MIL-V-25023B
Amendment -2
8 JULY 1969
Superseding
Amendment -1
14 March 1969

MILITARY SPECIFICATION

VALVE, FUEL DRAIN, SELF-LOCKING

Figure 1. Flow test containers for MS29529 and MS29530 valves

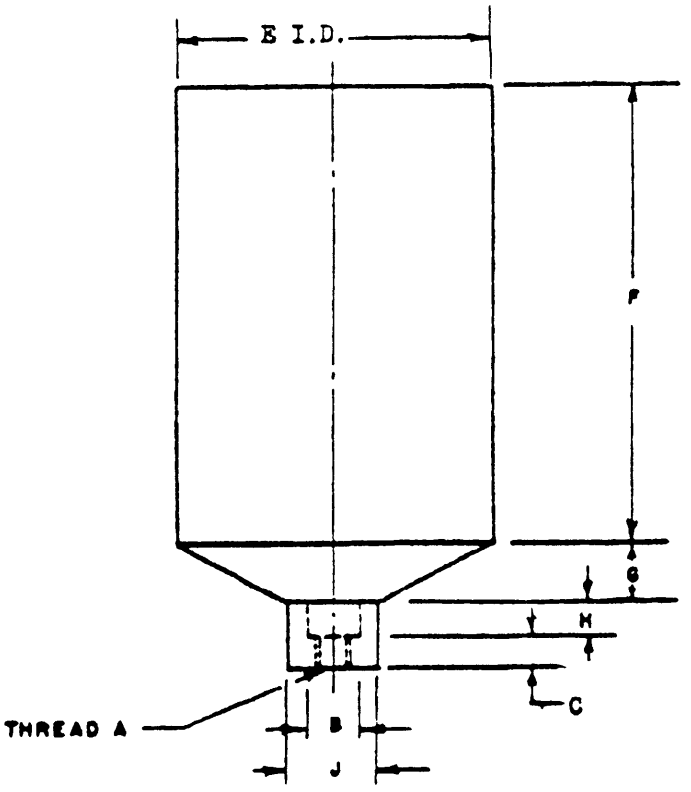
Page 8, figure 1: Delete, and substitute attached figure 1. Figure 1 forms page 2 of this amendment.

Figure 2. Flow test container for MS29528 valves

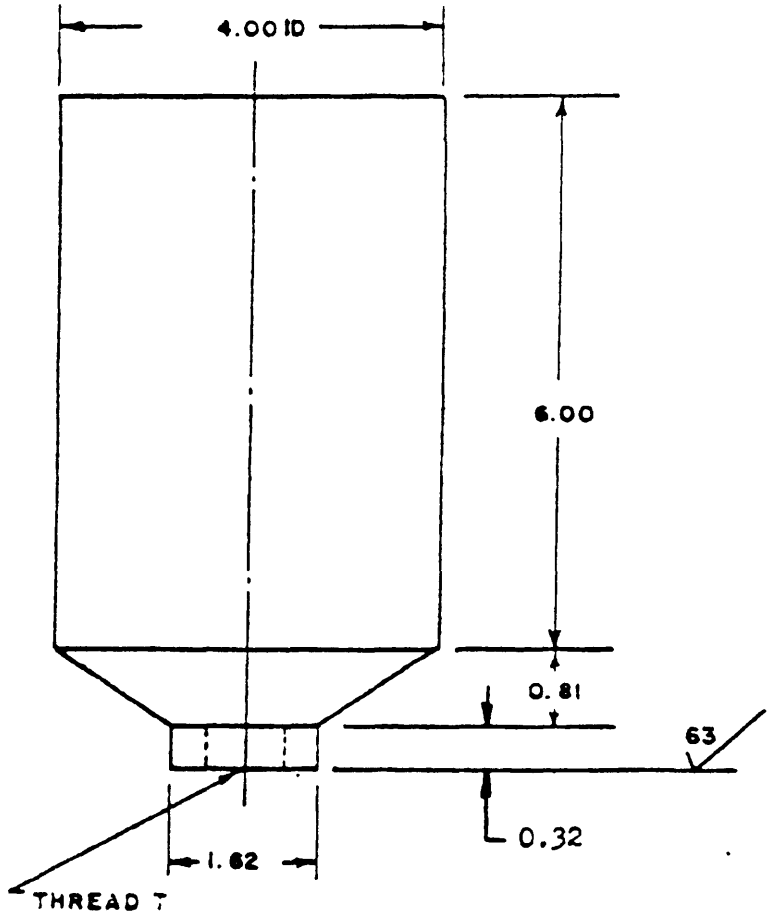
Page 9, figure 2: Delete, and substitute attached figure 2. Figure 2 forms page 3 of this amendment.

Figure 3. Flow test containers for MS29571 valves

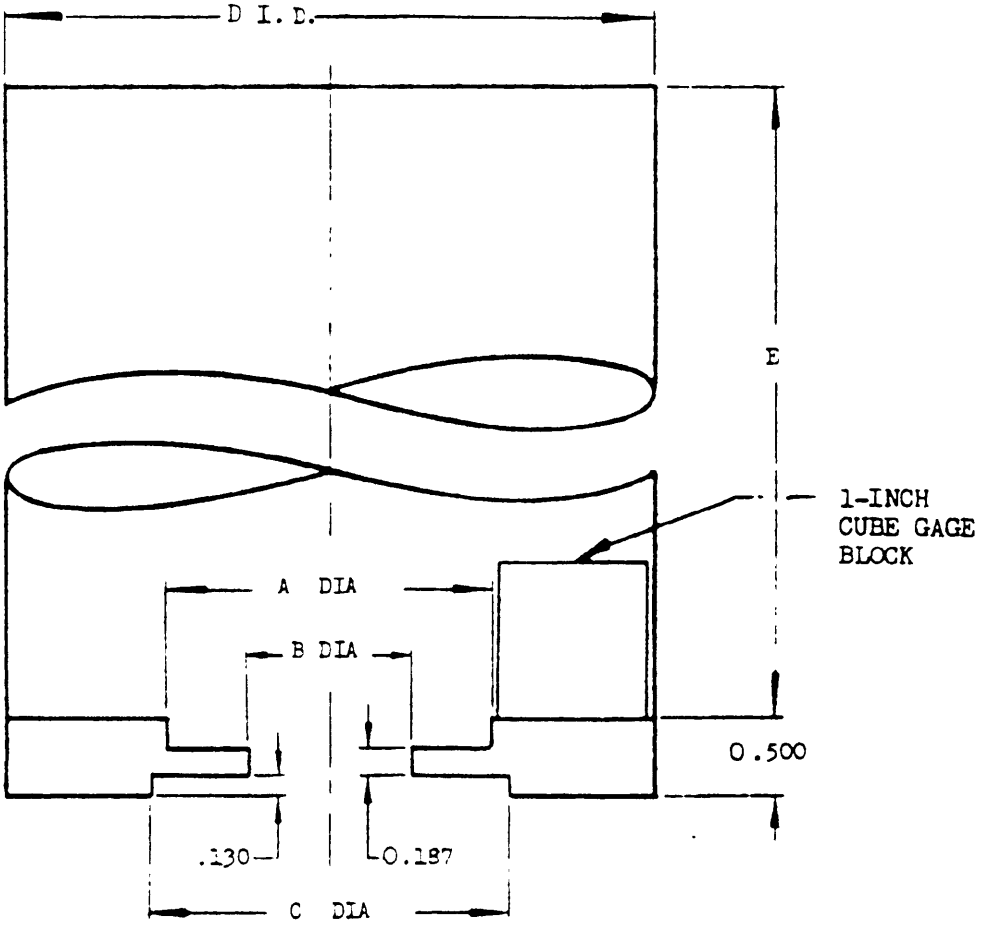
Page 10, figure 3: Delete, and substitute attached figure 3. Figure 3 forms page 4 of this amendment.
